# Comments on UNECE R No.141.01

Scenarios regarding proposal for driver-display of “Trailer TPMS not Equipped” in addition to Trailer TPMS Malfunction

elaborated by a small group of TF TPMSTI experts  
(TPMSTI-10-05)

27 Nov 2020

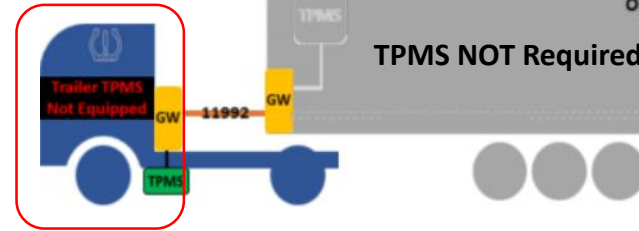
*Driver notified but Trailer TPMS not required*

# Additional Notification

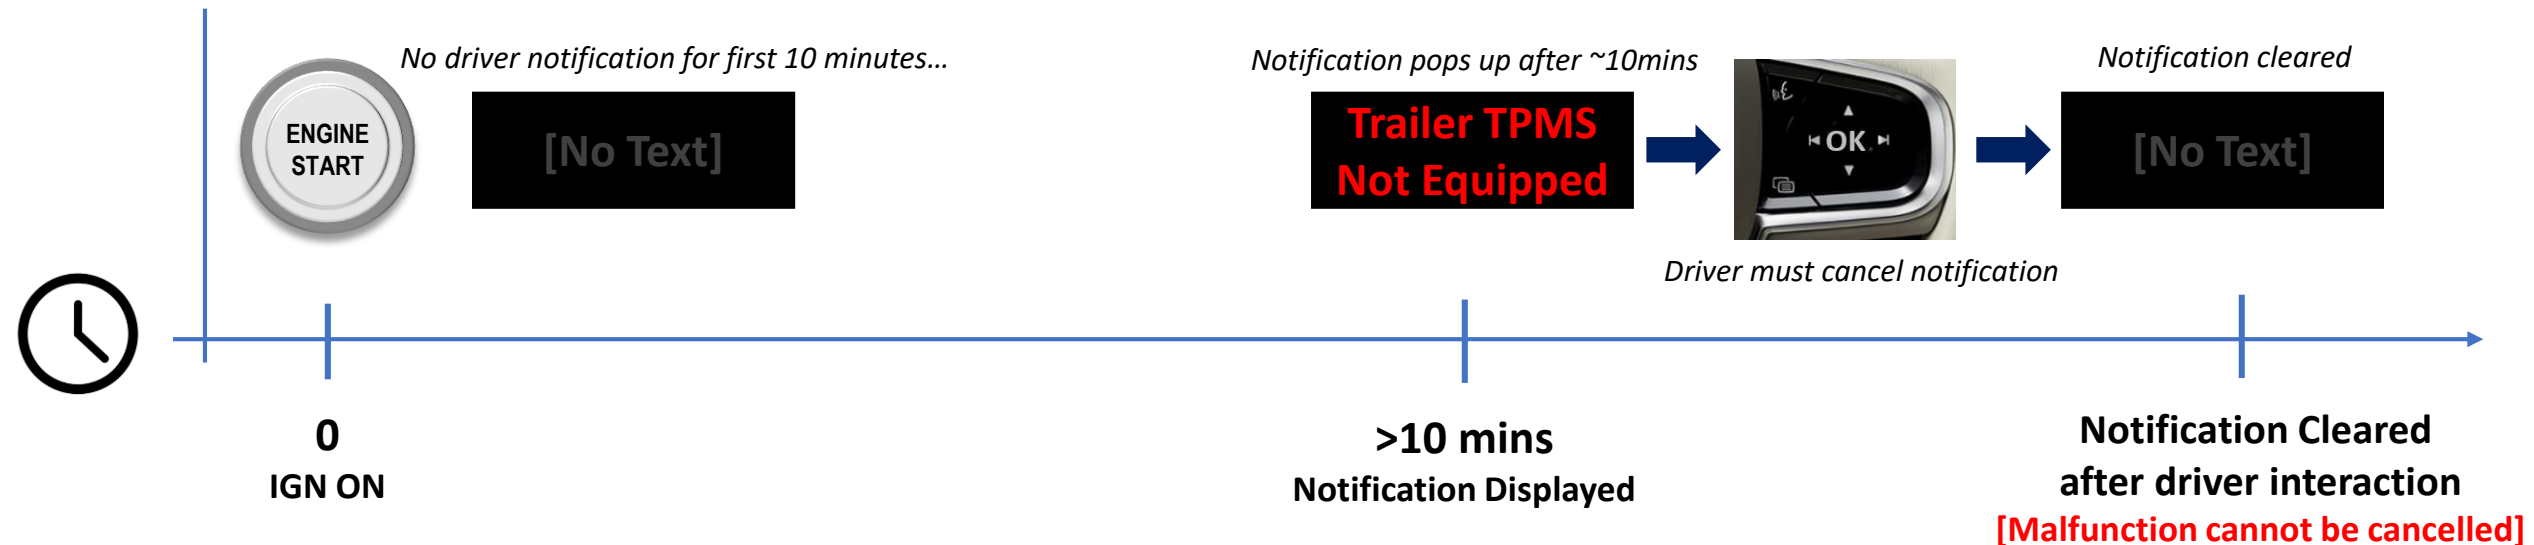
- If an additional notification was *mandated*...
  - There would be an additional requirement that all Truck manufacturers would have to implement this additional message display as well as a mechanism to dismiss the message

- It would need to be understood if this notification would need to be re-displayed:
    - *On every ignition ON event (after 10 minutes)?*
    - *Every time a **different** trailer is connected (truck would need to be able to detect that trailer is different)?*

- Note that, in case of a notification that “Trailer TPMS is not equipped”, the driver shall **not be able to cancel** the trailer TPMS malfunction.
- *If and additional notification was ‘Optional’...*

- If something is **truly optional** then it is optional whether or not it’s included in the regulation so it would be better to not include it at all.

- If Truck OEs want to display an additional message to drivers regarding trailer TPMS then they can choose to do so if they wish

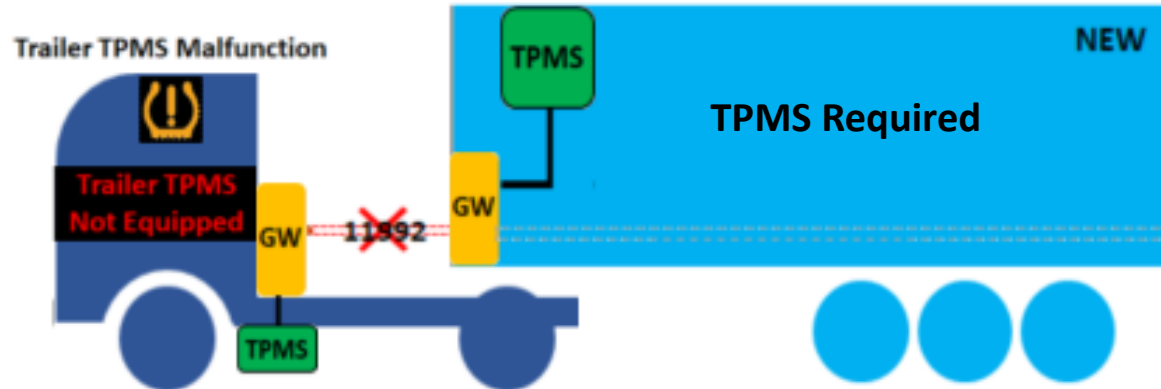
- New Trailer,
- TPMS equipped (+ Required)
- ISO 11992
- TPMS is working ok
- **Trailer TPMS Malfunction to Driver: NO**
- **Trailer Notification to Driver: NO**

- New Trailer,
- TPMS equipped (+ Required)
- ISO 11992
- TPMS is working ok but there is a **fault in the ISO 11992 ECL**
- **Trailer TPMS Malfunction to Driver: YES**
- **Trailer Notification to Driver: YES**

- In some scenarios, the truck would inform the driver that the towed trailer is **not equipped with TPMS** but this **would not be true**
- In these scenarios, a Trailer TPMS Malfunction would be appropriate
